DEPARTMENT OF THE AIR FORCE  
HEADQUARTERS 377TH AIR BASE WING (AFMC)

**Subject: Kirtland Air Force Base Bulk Fuel Facility – Groundwater Extraction Pilot Implementation and Additional Plume Characterization Letter Work Plan Addendum–Final**

**Proposed Amendments to the August 1, 2014 Work Plan and Approval Conditions of August 20, 2014**

# Figure 1. Screen Approval Form Monitoring Well Completion Diagram KAFB-\_\_\_\_\_

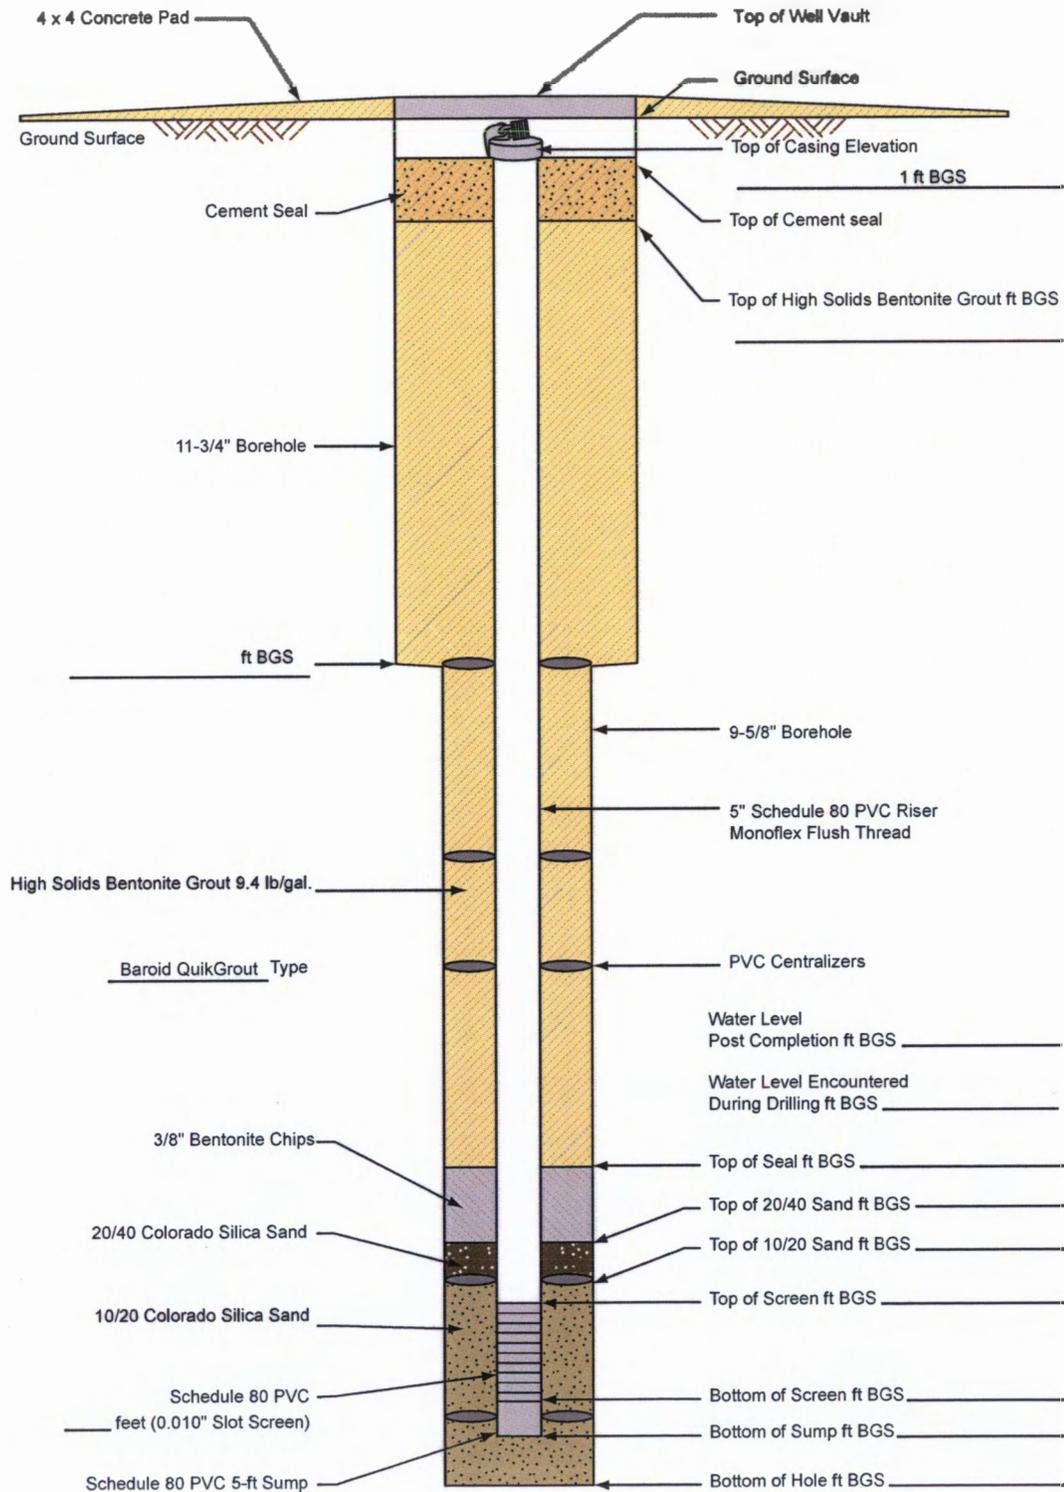
“For each of the additional 15 monitoring wells the Permittee shall provide a lithologic log and proposed screened interval to NMED for approval. NMED will provide a list of staff who will be available to receive, review and approve this information during drilling operations.”

The NMED will be notified two days prior to drilling and notified on the day an individual boring is completed. Upon reaching the total depth of the well, a qualified NMED representative will be available in the field to review the lithologic log and proposed screen interval for the well, and sign the screen interval approval form. Based on discussion with NMED, it is anticipated that the proposed screen interval will be approved or disapproved by the NMED field representative within 1 hour of its receiving the documents. If the screen interval is not approved, a decision will be made in the field to either set the screen higher, or drill the well slightly deeper to set the screen lower. See Figure 1 for the Screen Approval form.

The NMED will be notified two days prior to drilling and notified on the day an individual boring is completed. In accordance with Condition #3 in the August 20 NMED approval letter (NMED, 2014), upon reaching the total depth of the well, a qualified NMED representative will be available in the field to review the lithology log and proposed screen interval for the well, and sign the screen interval approval form. Based on discussions with NMED, it is anticipated that the proposed screen interval will be approved or disapproved by the NMED field representative within 1 hour of receiving the documents. If the screen interval is not approved, a decision will be made in the field to either set the screen higher, or drill the well slightly deeper to set the screen lower. See Figure 1 for the Screen Approval form.

The NMED will be notified two days prior to drilling and notified on the day an individual boring is completed. In accordance with Condition #3 in the August 20 NMED approved letter (NMED, 2014), upon reaching the total depth of the well, a qualified NMED representative will be available in the field to review the lithologic log and proposed screen interval for the well, and sign the screen interval approval form. Based on discussion with NMED, it is anticipated that the proposed screen interval will be approved or disapproved by the NMED field representative within 1 hour of its receiving the documents. If the screen interval is not approved, a decision will be made in the field to either set the screen higher, or drill the well slightly deeper to set the screen lower. See Figure 1 for the Screen Approval form.
